Access Compliance Report

Public Rights-of-Way

(Curb Ramps)

Intersection ID: 45787	Main Street: COPPER_TOP_CT	Cross Street: LONG_HILL_DR	Location: SW
ADA ID: B554E9FE5465	Ramp Type: Perp	Initial Pass/Fail: Fail	Overall Compliance: No
Codes/Mitigation Info/Possible Solution		Field Measurements/Component Compliance	
Severity Score: 21.25

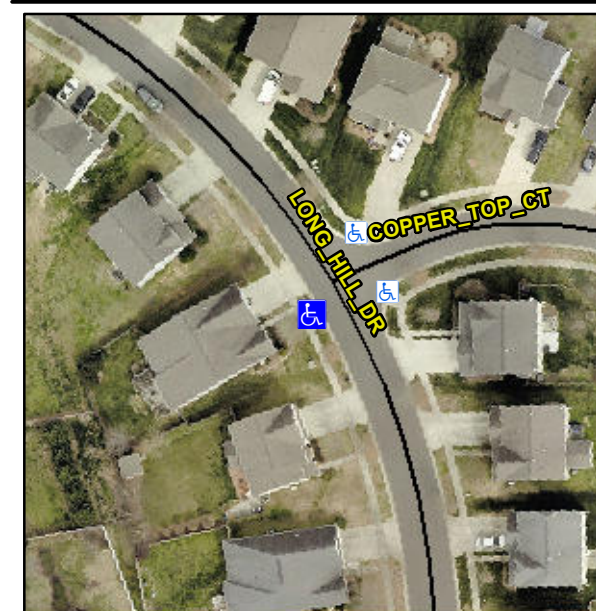
Not Found, R304.5.1, R304.5.3

Compliance	Description	Data	Compliance	Description	Data
N/A	Ramp Length (in)	70.5	Yes	Ramp Slope (%)	5.6
No	Ramp Width (in)	47.0	No	Ramp XSlope (%)	6.6
N/A	Flare Type LT	N/A	N/A	Flare Type RT	N/A
N/A	Flare Slope LT (%)	N/A	N/A	Flare Slope RT (%)	N/A
N/A	Flare Traversable LT?	N/A	N/A	Flare Traversable RT?	N/A
N/A	Landing Length (in)	N/A	N/A	DWS Provided?	N/A
N/A	Landing Width (in)	N/A	N/A	DWS Contrast?	N/A
N/A	Landing Slope (%)	N/A	N/A	DWS Length (in)	N/A
N/A	Landing X Slope (%)	N/A	N/A	DWS Full Width?	N/A
N/A	Landing Curb? (Y/N)	N/A	N/A	DWS Offset (in)	N/A
N/A	Shared Landing?	N/A			
N/A	Gutter Ponding?	N/A	N/A	Gutter Slope (%)	N/A
N/A	Gutter Lip Ht (in)	N/A	N/A	Gutter X Slope (%)	N/A
N/A	Painted X Walk1?	No	N/A	Painted X Walk2?	N/A
	X Walk 1 Direction	To E		X Walk 2 Direction	N/A
N/A	X Walk 1 Width (in)	N/A	N/A	X Walk 2 Width (in)	N/A
	X Walk 1 Slope (%)	3.0		X Walk 2 Slope (%)	N/A
	X Walk 1 X Slope (%)	4.2		X Walk 2 X Slope (%)	N/A

Remove & Replace Entire Ramp.
